PROGRESS REPORT

Independent Review of Implementation of Revised Seismic Design Criteria Hanford Waste Treatment and Immobilization Plant (WTP)

Revision D

U.S. Army Corps of Engineers
Walla Walla District

Figure SM-85-1

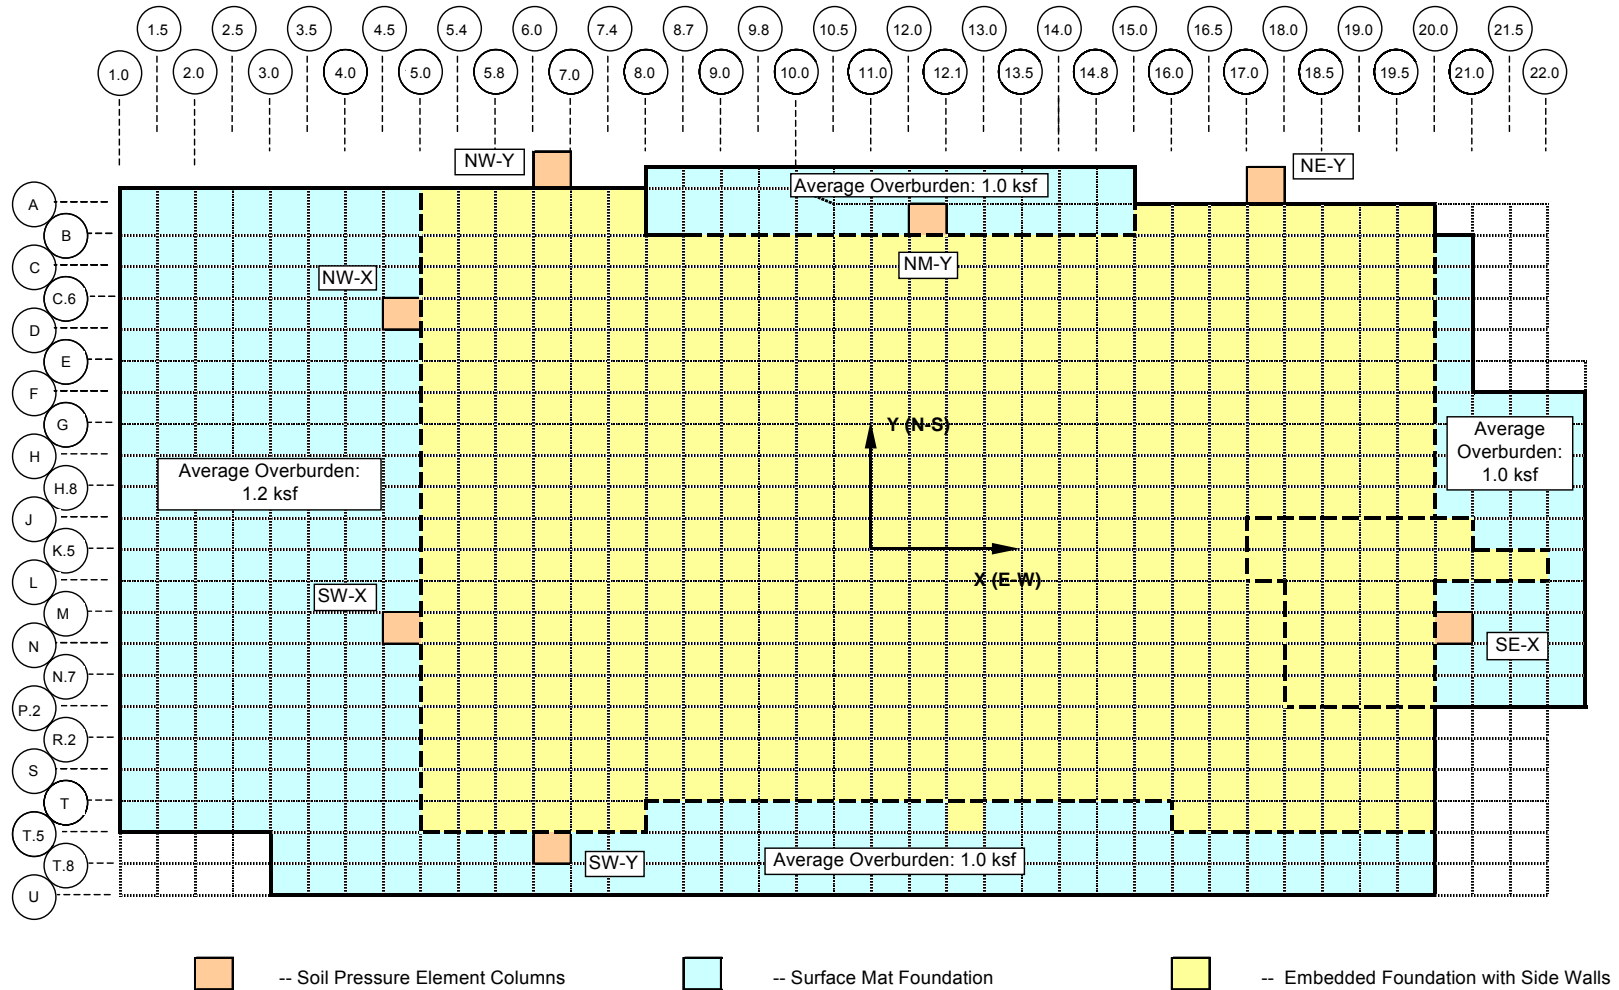
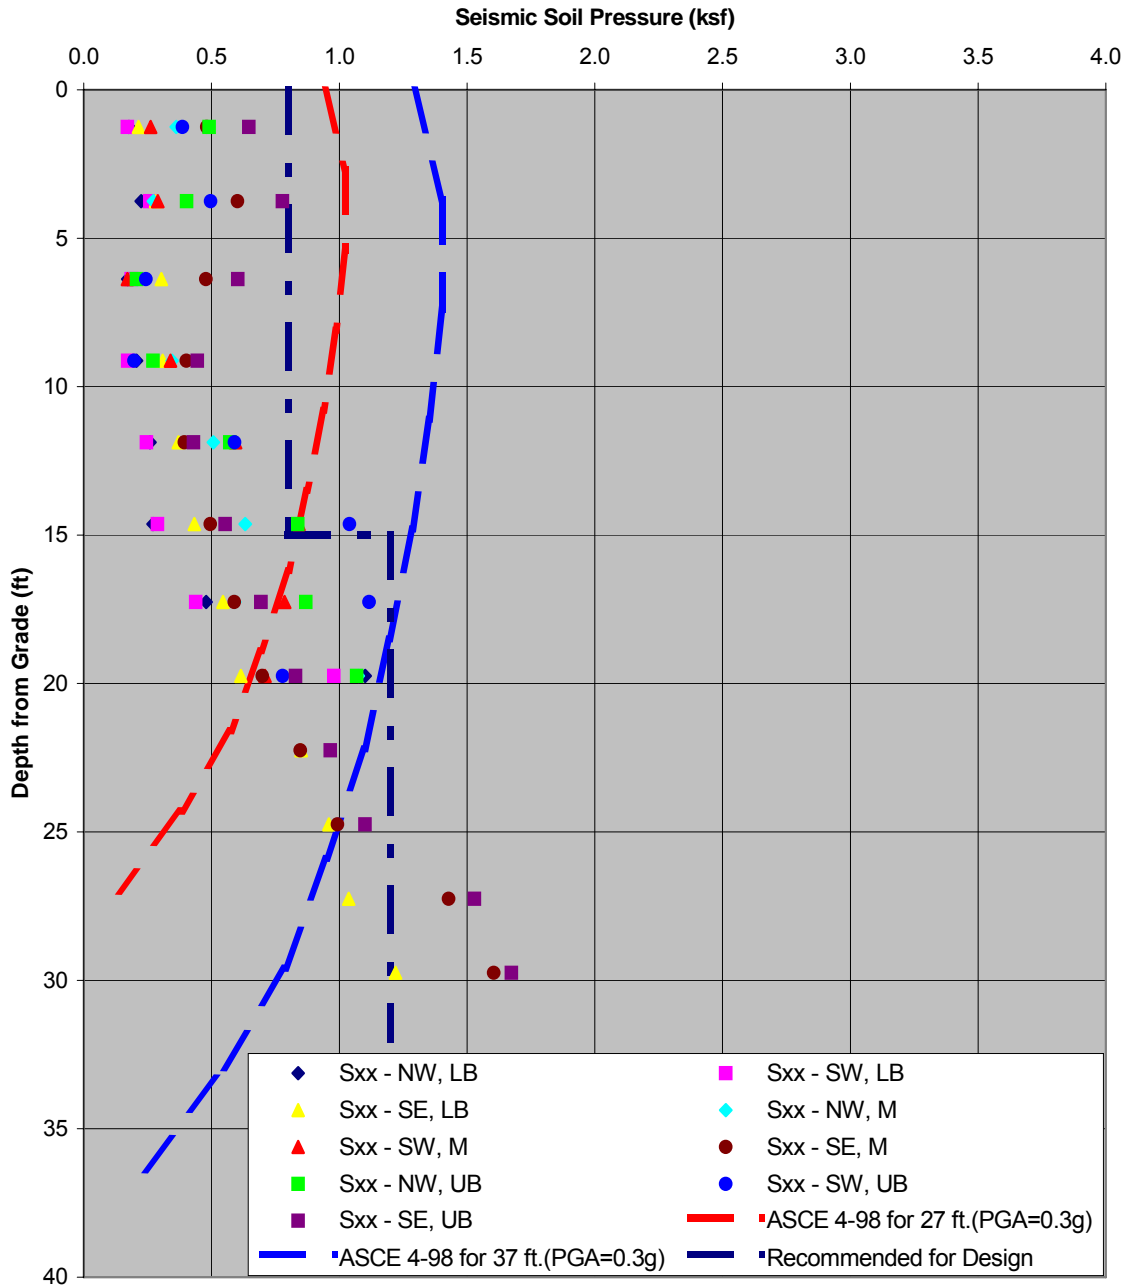
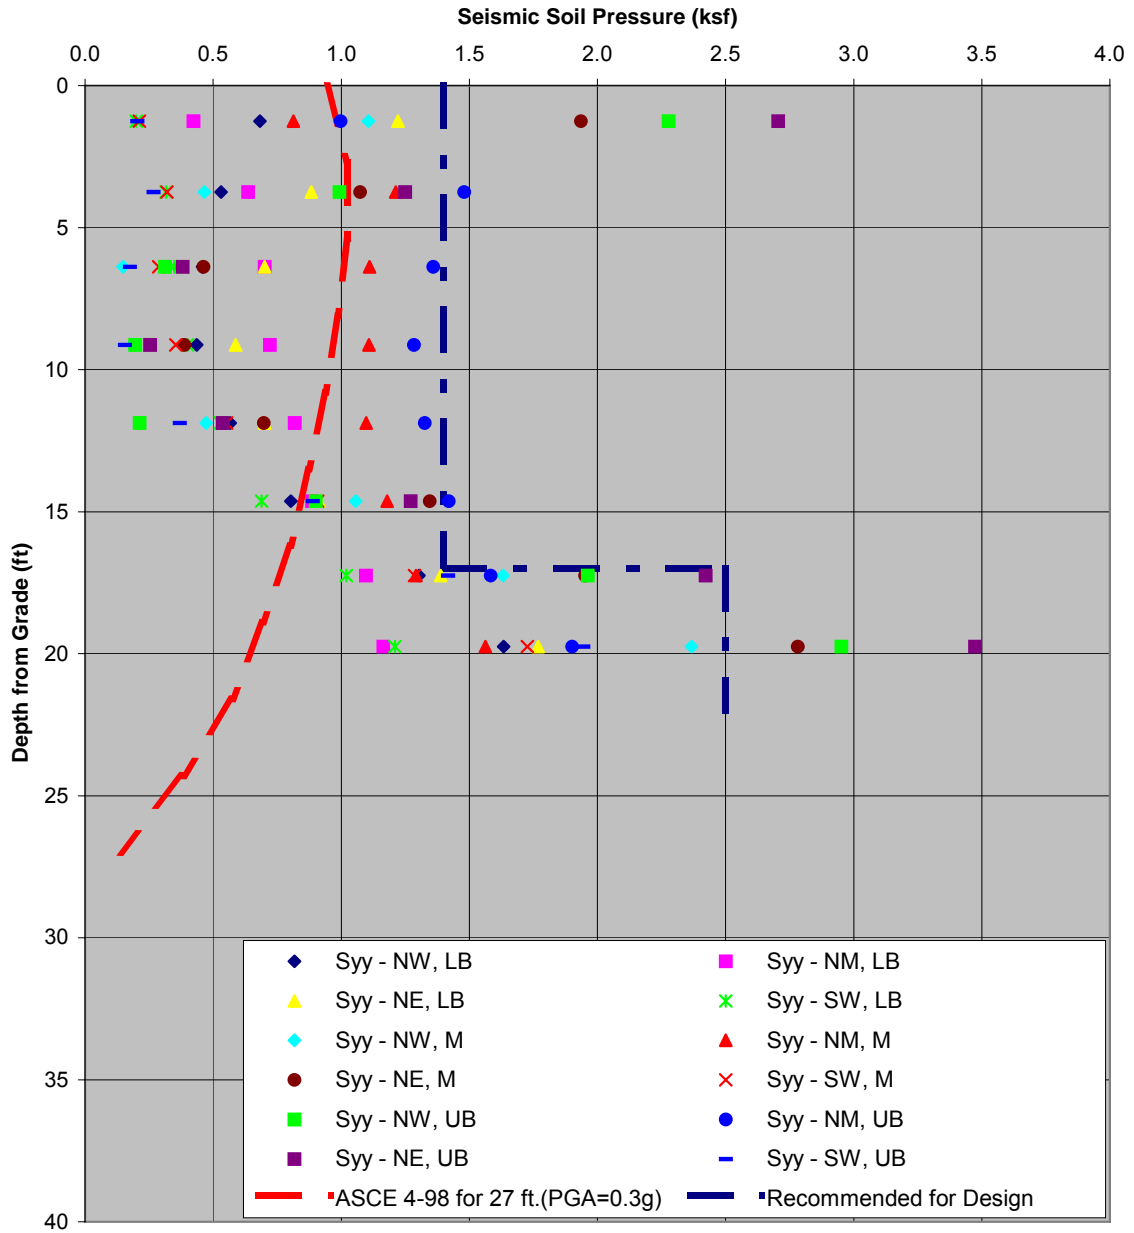
C.2 Structural Modeling Review Comments Phase II				
No.	Document	Comments and Observations	BNI Remarks/ Resolutions	Follow-up by USACE Review Team
		<p>These large differences in loads on the underground walls in each direction need some justification in the calculation.</p> <p>In north-south direction, the SASSI computed soil pressures are presented in Figure 7-48 of the SSI calculation. There are 3 soil pressure elements along the north side of the building and one soil pressure element on the south side of the building. At depths down to 12 feet below grade, the soil pressures on the north wall are a factor of more than 5 greater than the soil pressure on the south wall (comparing NM-UB to SW-UB). The NM-UB and SW-UB soil pressures are relatively constant with depth and the upper bound soil case governs the soil pressures. The large differences in soil pressure from the north side of the building to the south side of the building needs explanation.</p> <p>In the 3 north wall soil pressure elements, the distribution of pressure with depth is very different. As mentioned above, the NM-UB soil pressures are relatively constant with depth. However, for the NW-UB and NE-UB elements, the soil pressures are extremely large at</p>	<p>the surface slabs above where these soil strata are being dragged to move along with the wall. Therefore, the relative movement between the soil strata and the sidewall is reduced by this added restraint.</p> <p>It is worth to point out that the recommended soil pressure distribution in ASCE 4-98 was based on finite element results of free-standing rigid retaining walls. While the soil motion is also pure translational, the surface of soil backfill is free to move without added restraint. The presence of the surface slabs which are connected to the side walls is the main factor that causes the X-direction soil pressure to be smaller than the ASCE 4-98 values.</p> <p><u>Group 2—North-South soil pressure at South wall (@ column line T.5):</u> Refer to Figure SM-85-1, a surface reinforced concrete slab was added south of column line T.5. Therefore, this soil column is similar to those in Group 1 above. For the same reason as stated above for Group 1, the calculated soil pressure for Group 2 is also relatively low.</p> <p><u>Group 3—North-South soil pressure at East and West sides of North wall @ column line A:</u> At both of these locations, there is not any surface slab</p>

C.2 Structural Modeling Review Comments Phase II				
No.	Document	Comments and Observations	BNI Remarks/ Resolutions	Follow-up by USACE Review Team
		<p>grade and at 20 foot depth but the soil pressures are very low near 10 foot depth. It would be useful to understand the reasons for these differences in pressure distributions. In all cases, the distributions are different than Figure 3.5-1 of ASCE 4.</p> <p>It is not apparent how the soil pressures presented in Figures 7-47 and 7-48 were evaluated from the SASSI output files given in Attachment F of the SSI calculation. A road map along with intermediate calculations is required to understand these loads.</p>	<p>on top of soil. In the North-South direction, the exterior wall is connected to the interior core of the building by steel struts at elevation 0' and by reinforced concrete basemat at elevation -21'. These structural connections provide the mean of transferring (1) inertia forces of the massive interior, and (2) NS stiffness of the building, to the exterior wall. The connections at these 2 elevations provide the extra stiffness as well as the driving inertia force to the exterior wall. This created more interaction between the exterior wall and the soil column, thus, higher soil pressure at those 2 elevations. Between elevations 0' and -21', the exterior wall is free standing without any structural connections to the interior core of the building. Therefore, the exterior wall is more likely to move with the surrounding soil, and thus lower interaction and lower soil pressure between elevations 0' and -21'.</p> <p><u>Group 4—North-South soil pressure at center of North Wall @ column line B:</u> At this location, the exterior wall is connected to a N-S wall between elevations 0' and -21'. This N-S wall provides relatively "rigid" stiffness to the exterior wall in the out-of-plane (NS) direction. Locally the exterior wall is deformed similar to a rigid body, thus, distribution of the soil pressures are</p>

C.2 Structural Modeling Review Comments Phase II				
No.	Document	Comments and Observations	BNI Remarks/ Resolutions	Follow-up by USACE Review Team
			<p>closely matching a straight line as shown in Figure SM-85-3.</p> <p>In summary, above groups 1 thru 4 point out the reasons of the varying soil pressure as shown in Figures SM-85-2 and SM-85-3. Therefore, the soil pressures shown in these 2 figures are judged to be reasonable and correct.</p> <p>Furthermore, in response to the same reviewer's comment of SM-7 (refer to correspondence CCN 137083 & CCN 137417²) that the higher soil pressure peaks in the latest revision due to increased earthquake intensity can possibly increase the chance of soil/wall separation during earthquake shaking, it is worth to point out that all concrete shear walls in the HLW building are designed to go directly from upper portion of the building to the basemat at El. -21', while the exterior concrete walls from ground surface generally support the steel framing on the sides of the building. For this reason, the seismic load path for the structure is primarily from floor slabs to concrete walls to the basemat at Elevation -21 ft. Thus, most of the lateral inertial load is resisted by the base shear. Calculations show that a total of less than 10% of lateral inertial load is resisted by the sidewalls. Furthermore, the latest revision of the design (Rev. 0D) expands the surface</p>

C.2 Structural Modeling Review Comments Phase II				
No.	Document	Comments and Observations	BNI Remarks/ Resolutions	Follow-up by USACE Review Team
			slab to cover the entire length of the southern side of the building (Figure SM-85-1). The effects of both surface slab restraint and the overburden load on the slabs further reduce the possibility of soil/wall separation along the southern side of the building. The only area where soil/wall separation might occur is on the northern side with no surface slab, as identified by NW and NE soil columns. However, this area is designed as elevator wells. The sidewall is designed to stand by itself; it does not carry any load from the building. The potential soil-wall separation in this limited area is not expected to change the response of the buildings for design parameters obtained for design.	
SM-86	24590-HLW-SOC-S15T-00007 - SSI Analysis	<p>Reviewer: Stephen A. Short</p> <p>It is noted on Sheet 11 of the SSI calculations that based on the SASSI computed transfer functions, east-west direction seismic responses appear to be greater than north-south direction seismic responses. This observation is also true in ISRS and base shear results presented elsewhere. The fixed base fundamental frequencies of the HLW are about 9 Hz in the east-west direction and 11 Hz in the north-south direction. It is difficult to assess the frequency of the soil-structure system from the transfer</p>	<p>USACE:</p> <p>“Observation</p> <p>See comment SM-5 & 29 on narrow peak response spectra.”</p> <p>BNI/Khan:</p> <p>USACE refers to SM-5 & 29 in their remarks. Although these two comments were included in informal communiqués to BNI from ORP, these comments were acknowledged by ORP as being ORP’s action and were therefore excluded from the formal transmittal of comments in ORP letter CCN 137083 (06-WED-012</p>	Closed
